Agenda
Village of Arlington Heights
Zoning Board of Appeals
Buechner Room, 1st Floor
Arlington Heights Village Hall, 33 S. Arlington Heights Rd.
January 8, 2024
7:00 PM

Prepared By: Derek Mach, Planner
Hearing Date: January 8, 2024
Date Prepared: January 3, 2024
Project Title: Leahy Residence
Address: 515 N. Chestnut Ave.

Prepared By: Steve Hautzinger, Design Planner
Hearing Date: January 8, 2024
Date Prepared: January 3, 2024
Project Title: 720 N. Dunton Ave.
Address: 720 N. Dunton Ave.

FRONT ELEVATION - EXHIBIT 4:
STAFF EXHIBIT SHOWING GRADING.
Prepared on 12-14-23 based on As-Built Roof Height Survey, Architectural and Grading permit plans

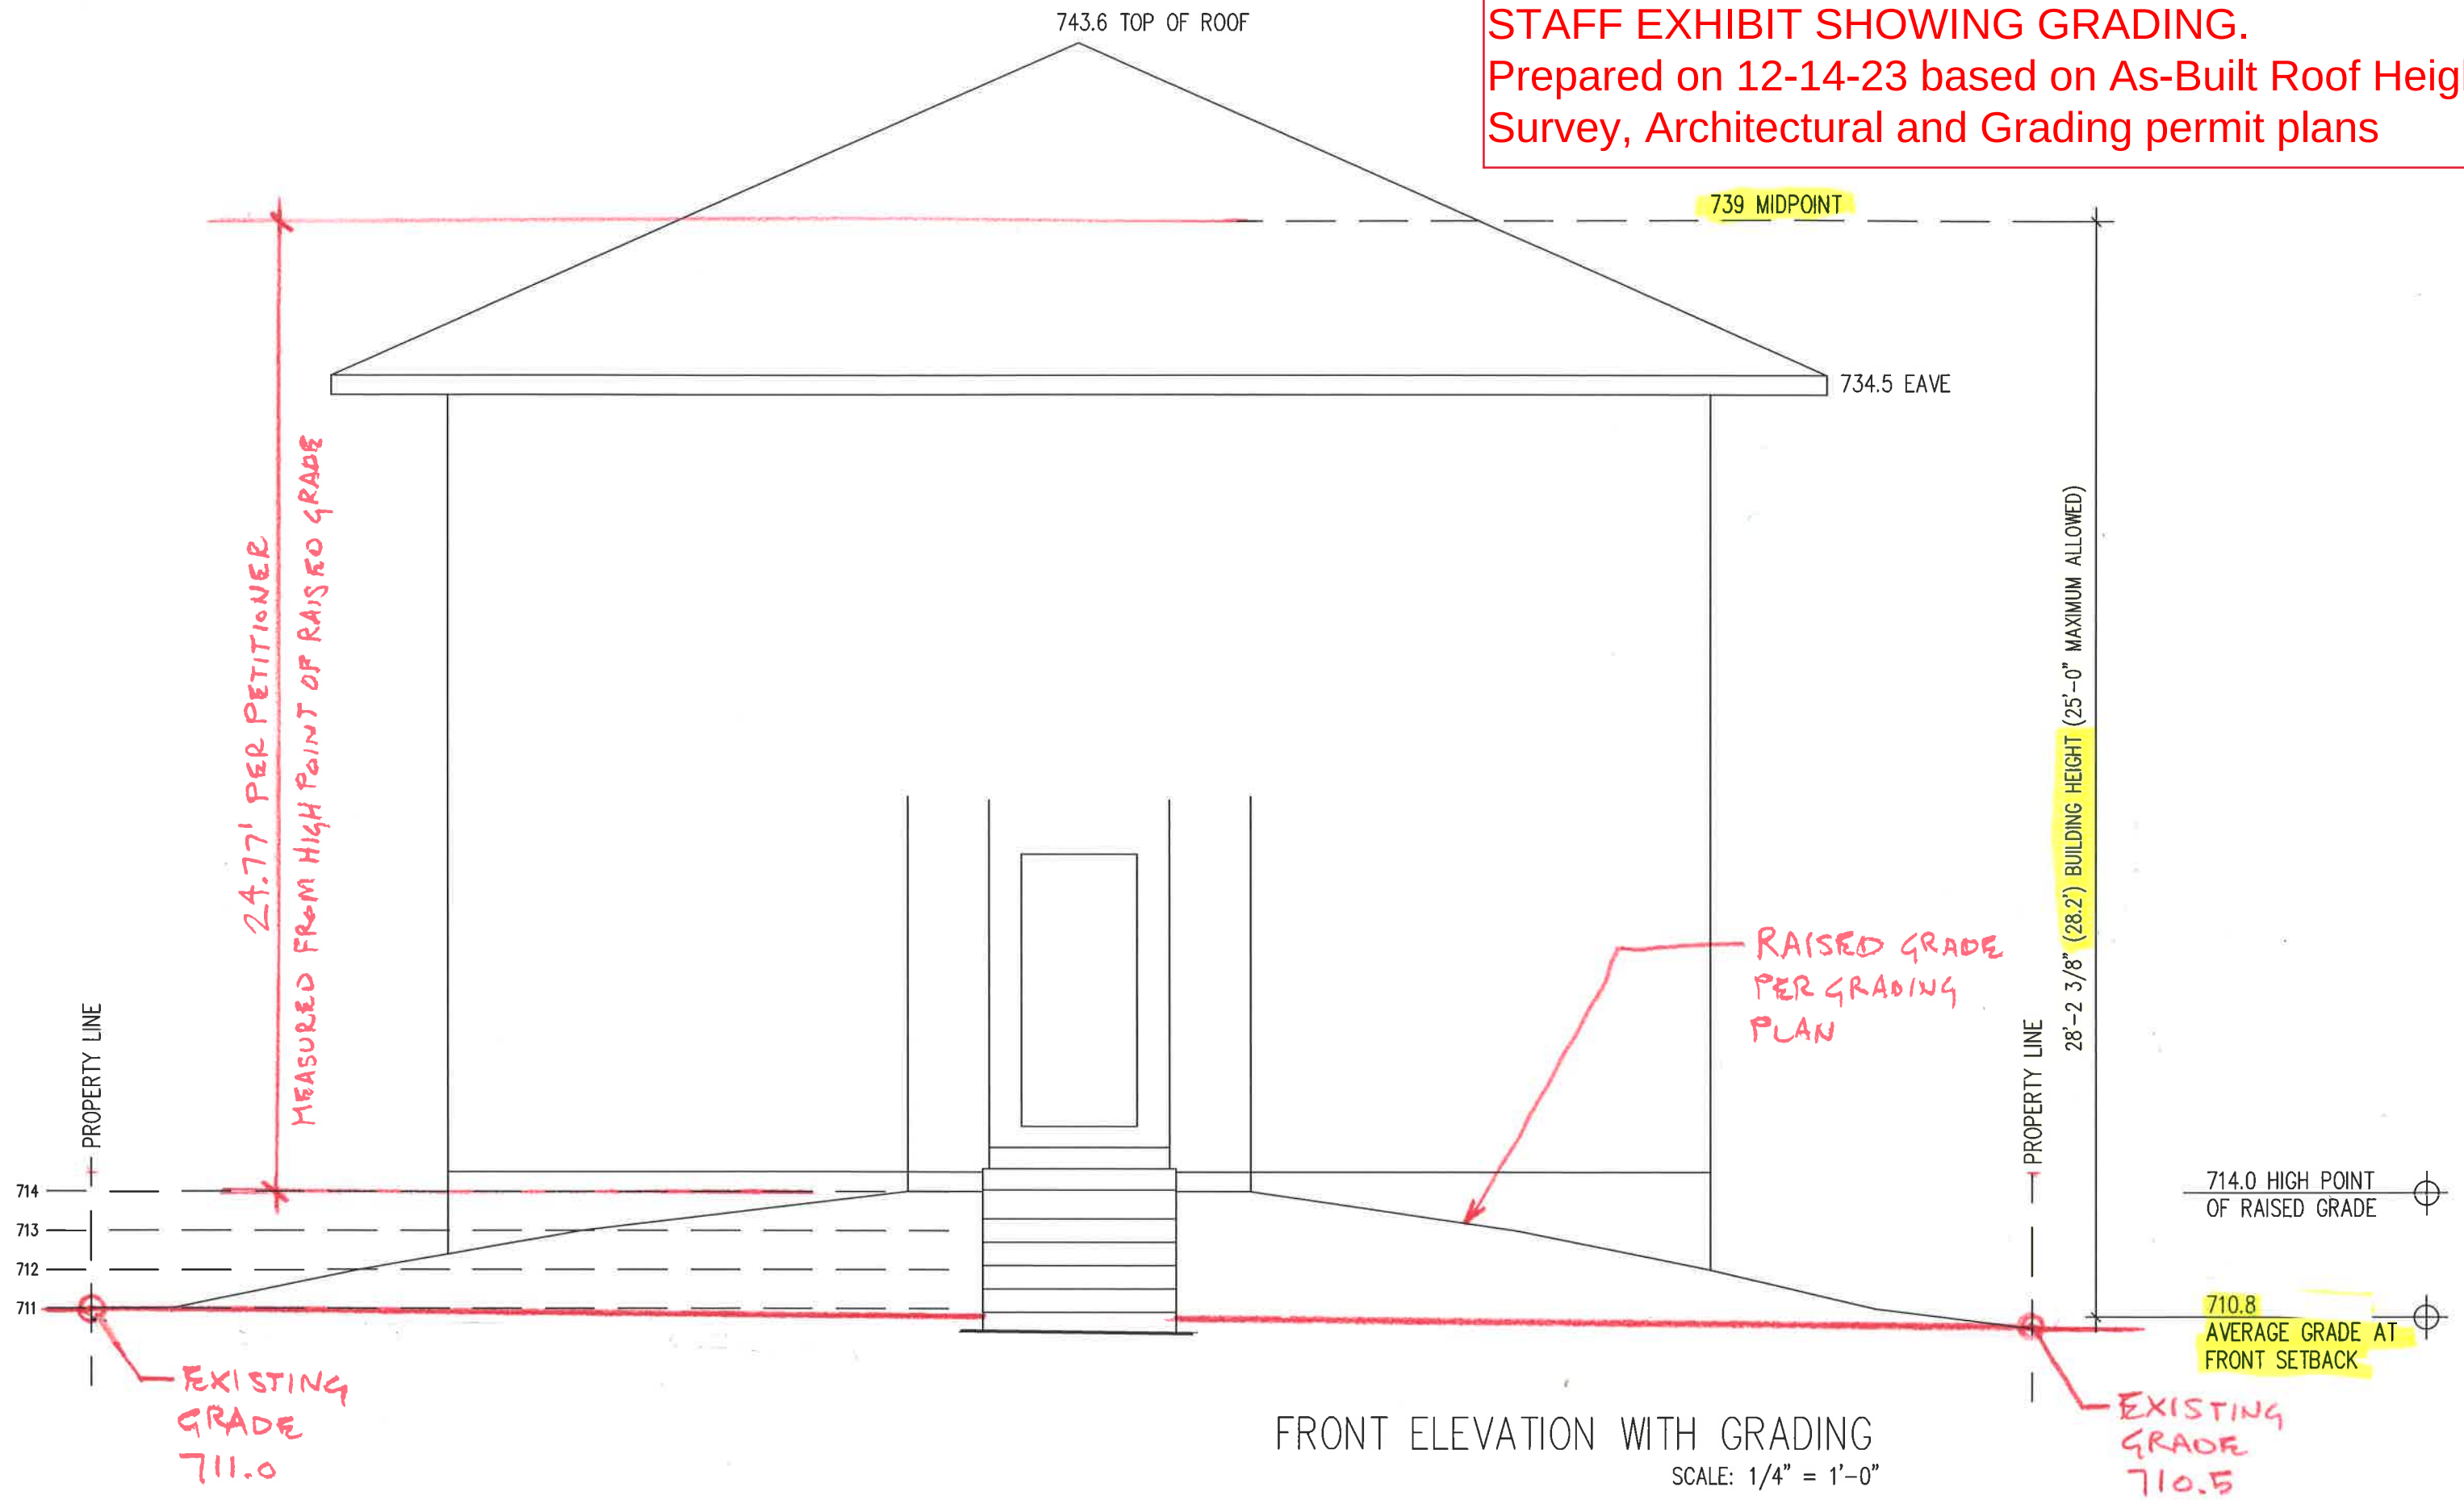
Staff's determination of "**the average elevation of the finished lot grade at the front of the building**" for measuring the building height is based on Chapter 23, **Section 23-103 General Lot Grade Maximums**, which states "**No lot shall be graded in such a manner as to raise the grade of such lot to any point higher than a continuous grade level between the grades of the lots on either side abutting such lot.**" Based on this requirement, the correct application of the municipal code for determining the building height is to measure from the average grade level between the existing grades of the lots on either side abutting the subject property at the front building setback. The existing grade elevation at the 25.5' front building setback line is 711.0 on the south lot line and 710.5 on the north lot line, with an average elevation of 710.8. The building height is measured from the average elevation of the existing grade (710.8) to the midpoint of the roof (739.0). **Therefore, staff's determination of the building height is 28.2 feet, where 25 feet is the maximum allowed** (refer to Front Elevation-Exhibit 4).

According to the site engineering plan, the elevation of the artificially raised grade is 712.0 at the northeast corner of the foundation. The high point of the artificially raised grade at the front building setback is 714.0. The average elevation of the artificially raised grade at the foundation wall across the front of the building is 713 (midpoint of 714.0 and 712). If the building height is measured from this elevation (713) to the midpoint of the roof (739.0), then the building height is 26 feet, where 25 feet is the maximum allowed.

SITE SECTION - EXHIBIT 5:
STAFF EXHIBIT prepared on 12-14-23 based on
Architectural and Grading permit plans

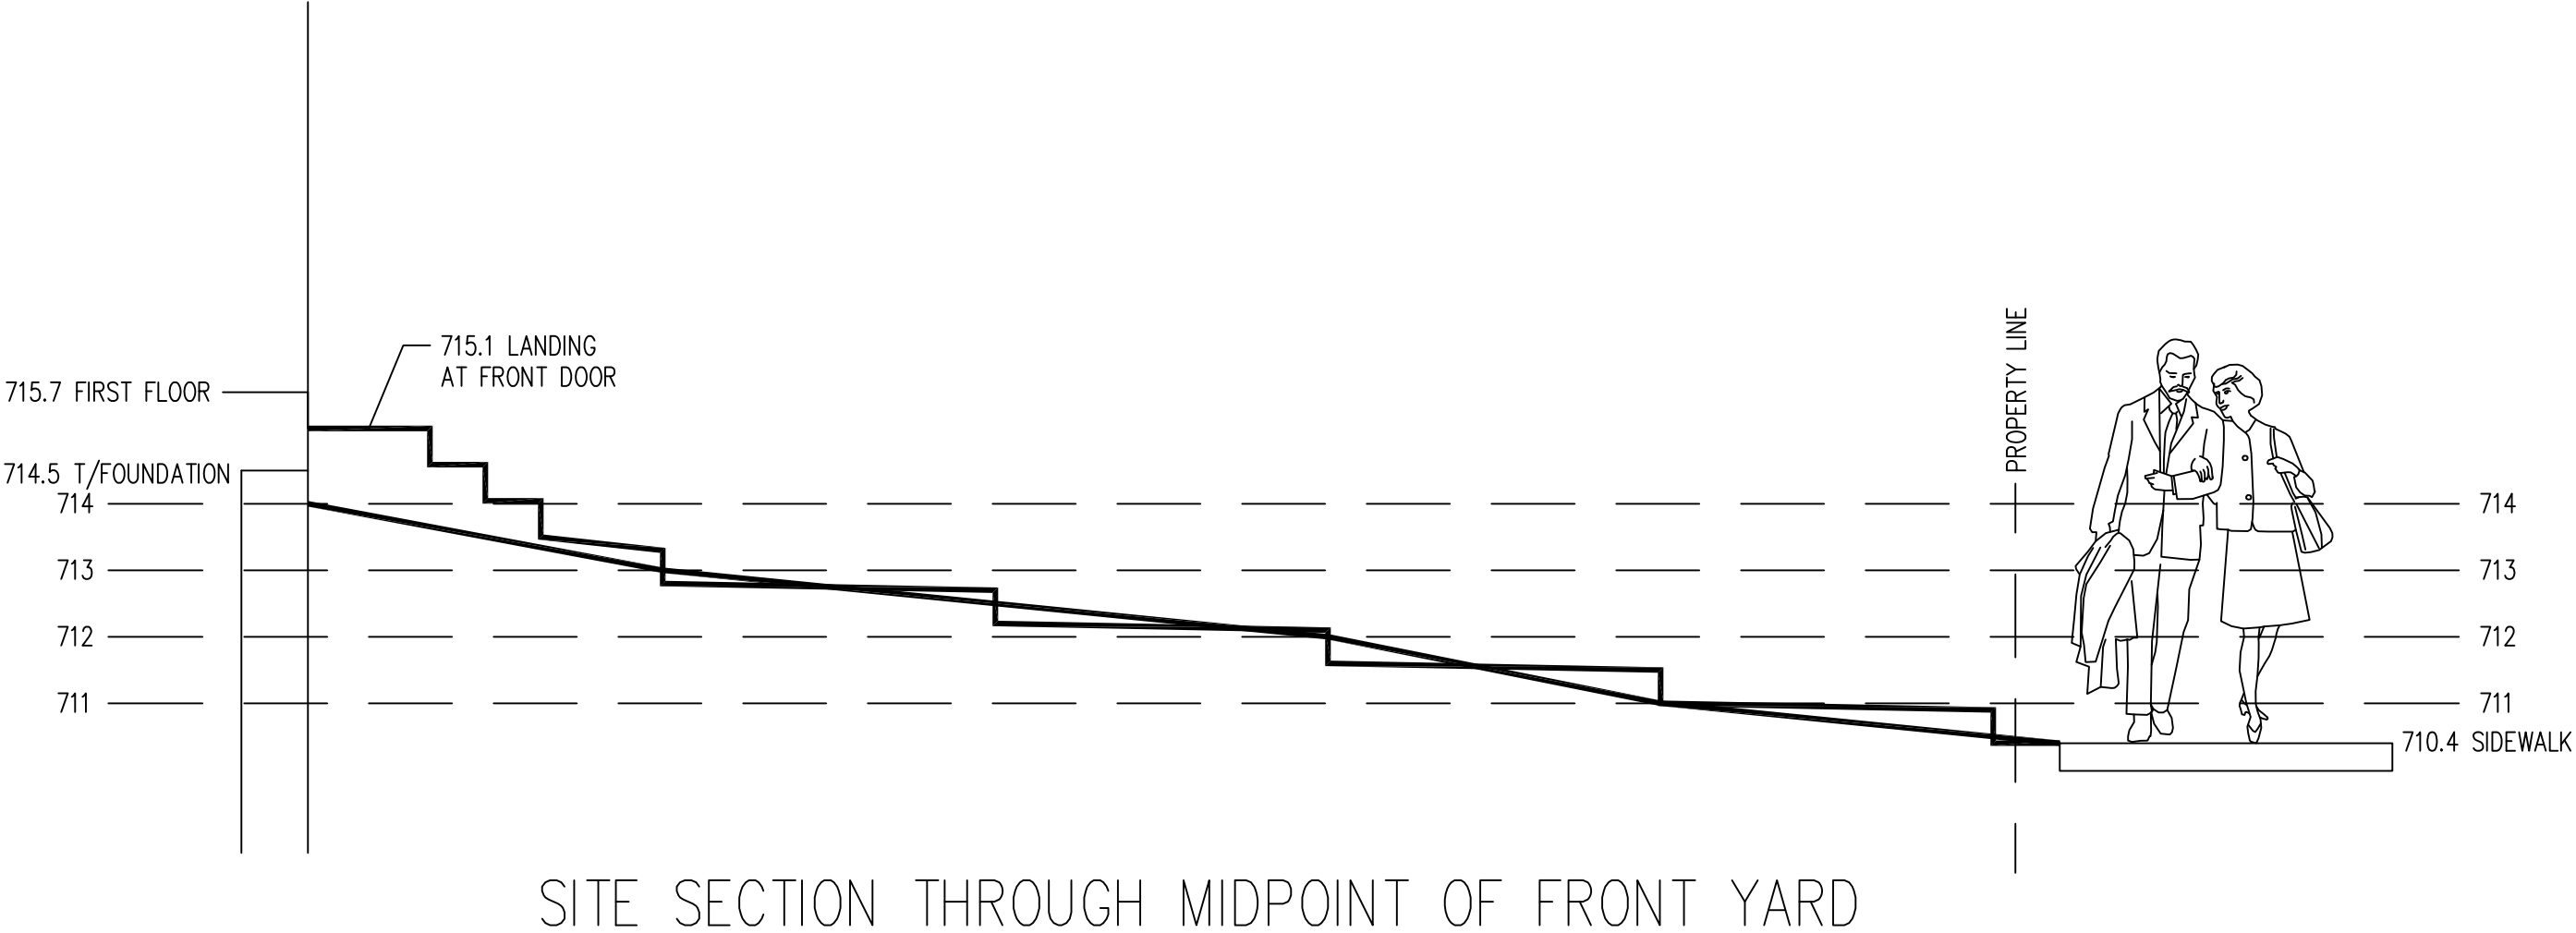
During construction, neighbors observed that the house under construction appeared to be taller than the design that was approved by the Design Commission. Upon receiving this complaint, Village Staff requested a height survey from the builder. It was discovered that the approved architectural building permit drawings were not coordinated with the site engineering grading plan for the project. The site engineering drawings showed that the site was not flat and level,

but instead had a slope of approximately three feet from the high point at the rear alley to the low point at the front public sidewalk. To make up for this drop in grade, the grading plan included a three-foot tall mound of dirt across the front of the house and six additional steps along the front walk to get up to the front door.
